Comment A – Some hydrologic considerations for storage of High-Level nuclear waste at the Holtec Site in Lea County, New Mexico

COMMENT (286)

CITATION # 83 FR 13802

5 **DOCKUM WATER LEVELS WITH FLOW LINES (FROM FUANG, 2008)**
 Figure 5.24 Simulated steady-state water levels and residuals in feet for the lower portion of the Dockum Aquifer. — GENERALIZED FLOW LINES DRAWN IN RED

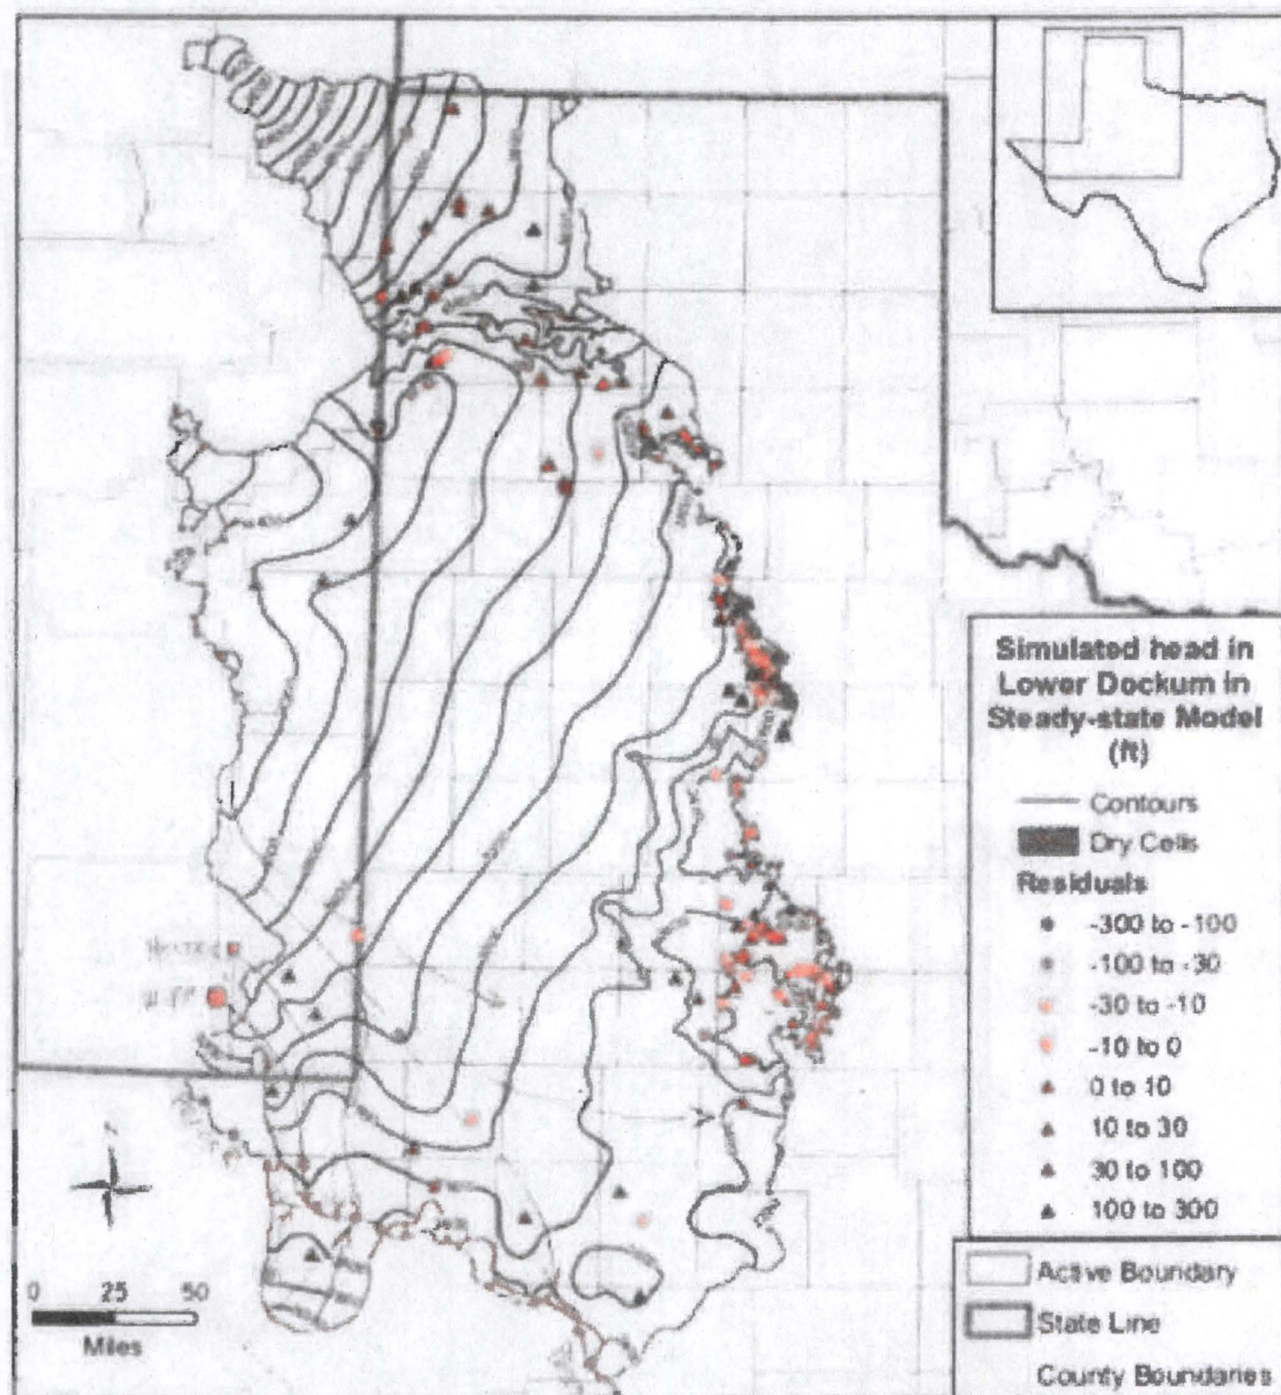
traveling contaminant fronts from HS could be entrained in ground-water flow within this aquifer and transported to the south and southeast towards commercial pumping centers (accessible environment) in southern Lea County, NM and Winkler County, TX (Ewing, 2008 – water-level map (Figure 5), flow lines, and pumpage map - Figure 6)), or possibly flow directly into the Pecos River in Ward County, Texas (Figure 5) and from there into the Rio Grande. Until subsurface work is done to check on the presence or absence of the Dockum aquifer below HS (or below a new location if the HS is moved), this problem is only a potential hazard. If geologic work is done to investigate this issue, it should be reviewed by independent agencies such as the USGS, the N M Bureau of Geology, and the NM .

FIGURE 7 - GENERAL LOCATION MAP AND CORBET MODEL BOUNDARIES
DRAWN ON BAKHMAN (1987) MAP OF RUSTLER FM.

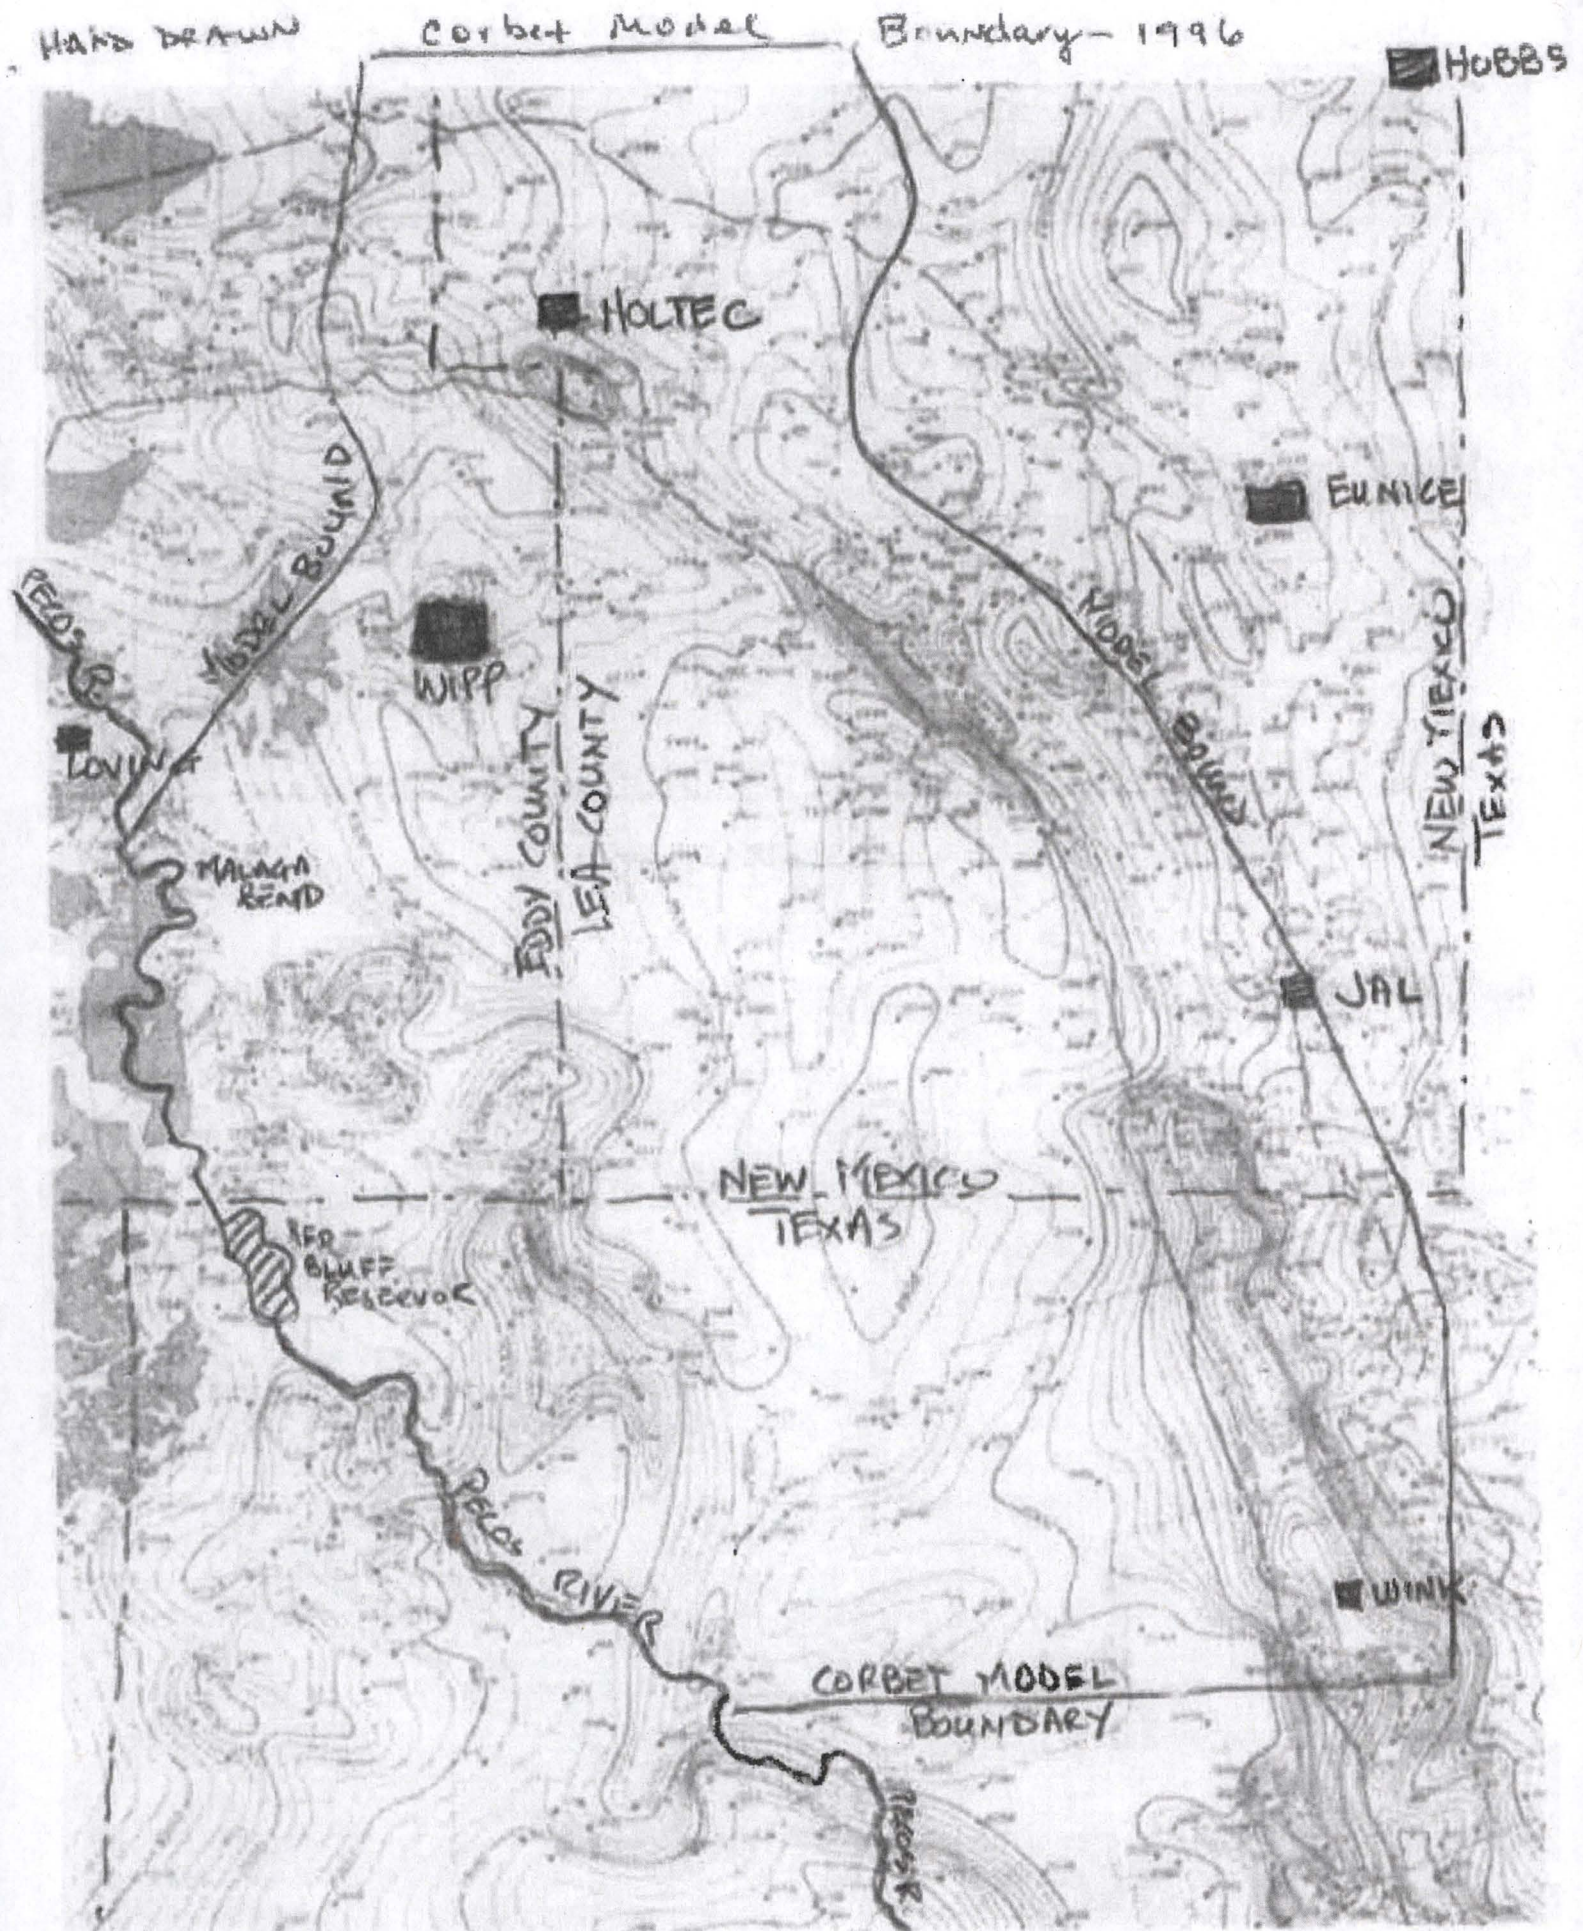
- C) - **Rustler Aquifer** - the Permian Rustler Formation and its aquifers lie beneath the HS (Bachman, 1987, Map of Rustler Fm – Figure 7). Deeper vertical contaminant transport through and below the Triassic within the bounds of HS could reach the Rustler Formation and there, contaminants could be transported southward in ground-water flow within this confined aquifer, and eventually taken into the Pecos River itself (Corbet, 1996, water-level map with flow lines – Figure 8) – and once again, eventually into the Rio Grande.. Hale (1945) suggested that saline waters within the Rustler Aquifer did flow into the Pecos River within New Mexico in the reach between Malaga Bend and the Texas State line (Figure 7). Within their modeled area (Figure 7), Corbet and Knupp (1996) describe the Rustler close to the Pecos River as grading into a permeable collapse breccia through which Rustler aquifer water within the modeled area flows into the Pecos River.
